REVISED RESPONSE TO REQUEST FOR ADDITIONAL INFORMATION

APR1400 Design Certification

Docket No. 52-046

RAI No.: 255-8285
SRP Section: 03.08.05 – Foundations
Application Section: 03.08.05
Date of RAI Issue: 10/19/2015

Figure 1 Jurisdictional Boundary for Design of Common Basemat

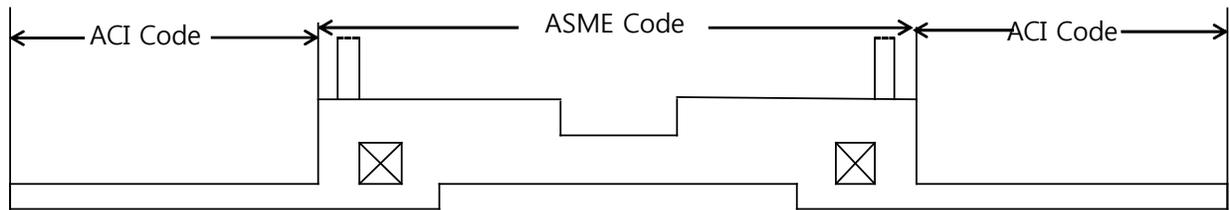
Technical Report (TR) APR1400-E-S-NR-14006-P, Rev 1, "Stability Check for NI Common Basemat," Section 3.2.6, "Load Combinations," states that, "The division of the basemat by code jurisdiction at the thickness transition is a logical choice, and the boundary of the code jurisdiction is conservatively designed using the greater forces from the analysis results of ASME and ACI codes." It is not clear to the staff as to how the applicant consider the loads and load combinations for the basemat of the containment and the Auxiliary building (AB), and how the applicant design the transition region. For example, it is not clear whether the division of the basemat code jurisdiction at the thickness transition is in accordance with the ASME Code Interpretation: 111-2-83-01, which covers this design configuration and how do they define the transition region. Per 10 CFR 50.55a; Appendix A to 10 CFR Part 50, General Design Criteria 1, 2, 4, 16 and 50; and SRP 3.8.5, the applicant is requested to describe in more detail how the loads and load combinations for the basemat of the containment and the AB, were considered in the analysis and how the transition region is design.

Load combinations and load factors for the RCB and the AB basemats are selected based on their relevant design codes, ASME and ACI respectively. The boundary of code jurisdiction between the ASME code and the ACI code is shown in Figure 1. The details of the code jurisdiction boundary are presented in the response to RAI 199-8223, Question 03.08.01-11.

For the design of the basemat, at the interface between the ASME and ACI codes, the larger amount of reinforcement required by either code was used.
